RSRNAS 2 Design Decision Estimation

Kazakh Research Institute of Water as a leading research organization on water problems works on scientific reasoning of water problems solution in the republic. The institute activity is a multi-faceted and an integral part of its activity is, particularly, a system research, analysis and evaluation of developed projects of hydro economic rebuilding in the river basins. One of such significant documents of the last time is the project of regulation of the Syr-Darya River and the north-end of the Aral Sea. The experts of the institute took part in the state expertise of this project and estimated its significance for ecological revival of the region.

Figure 1. The hydrographic characteristic of NAS.

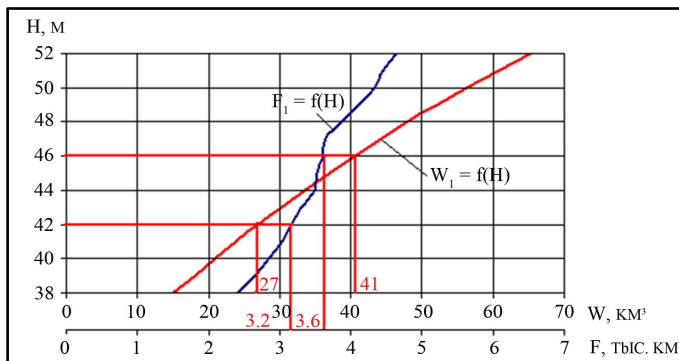
At the present time design engineers explain the refusal from the level of 50 m BS because of deficiency of water sources for keeping up water level in the cove at this mark. The calculations proved the inefficiency of this argument. The hydrographic characteristics of the NAS and the Saryshaganak cove are shown in [Figure 1](#) and [Figure 2](#).

These graphics show that for priming the NAS till the mark 50 m BS it is necessary $56 - 57 \text{ km}^3$ of water, and till the mark 46 m BS - 41 km^3 , nowadays the cubature of the NAS at the mark 42 m BS is 27 km^3 *i.e.* the additional cubature is 30 and 14 km^3 , at a year-round inflow it is necessary to deliver accordingly 951 and 443 m^3/sec of water. This increases the rate by 25% - 30% without taking into account the evaporation losses. Kazakhstan does not have enough resources in lower reaches of the Syr-Darya River.

Figure 2. The hydrographic characteristic of the Saryshaganak cove.

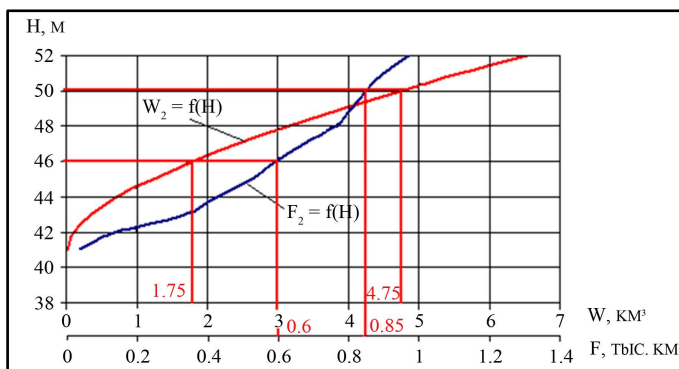
As for priming of the Saryshaganak cove the deal is more satisfactory. Cove priming at marks 46 and 50 m

BS will demand 1.75 km³ and 4.75 km³ of water, that comprise 55 and 150 m³/s, with allowance for evaporation loss the flow requirement can reach 70 and 195 m³/s. Such amount of water may be broken free for filling of the Saryshaganak cove, taking into account the design conditions of the Aklak hydro-electric power station.

In conclusion, we'll mark that the water level in the Saryshaganak cove must reach 50 m BS that provides well ecological and favorable regime in the project zone.
